**ADDENDUM NUMBER 2  
Prepared by  
M. B. Kahn Construction Co., Inc.  
Construction Management Division  
Columbia, SC  
The Boudreaux Group  
Columbia, SC  
Date of issue: October 27, 2010**

**Richland County Recreation Commission  
Package G – Polo Road Park Improvements**

Package "G" (Polo Road) Addendum No.2 Items:

Re: Polo Road Parking Lot and Irrigation Improvements  
Richland County Recreation Commission  
Columbia, SC  
BEA Project No. AB21003

**3** NEW PUMP HOUSE 3 ELECTRICAL PLAN  
 APPROX. SCALE: 1" = 50'-0"

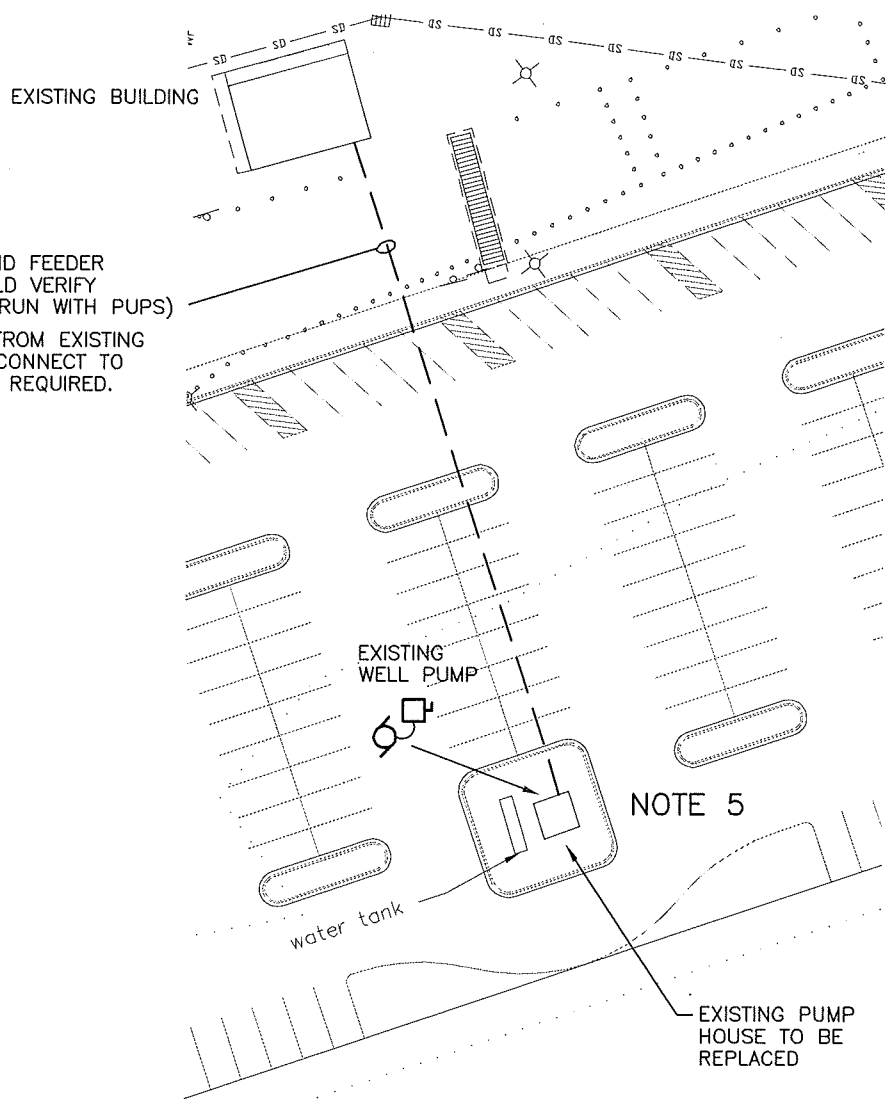
4. REFERENCE DRAWING E2.1 – For clarification, replace Detail 3 “New Pump House 3 Electrical Plan” with attached sketch SK-E-2. Sketch shows existing feeder to existing pump house that shall be disconnected, then reconnected to new pump house.

EXISTING UNDERGROUND FEEDER TO PUMP HOUSE (FIELD VERIFY ACTUAL LOCATION OF RUN WITH PUPS)  
 DISCONNECT FEEDER FROM EXISTING PUMP HOUSE AND RECONNECT TO NEW PUMP HOUSE AS REQUIRED.
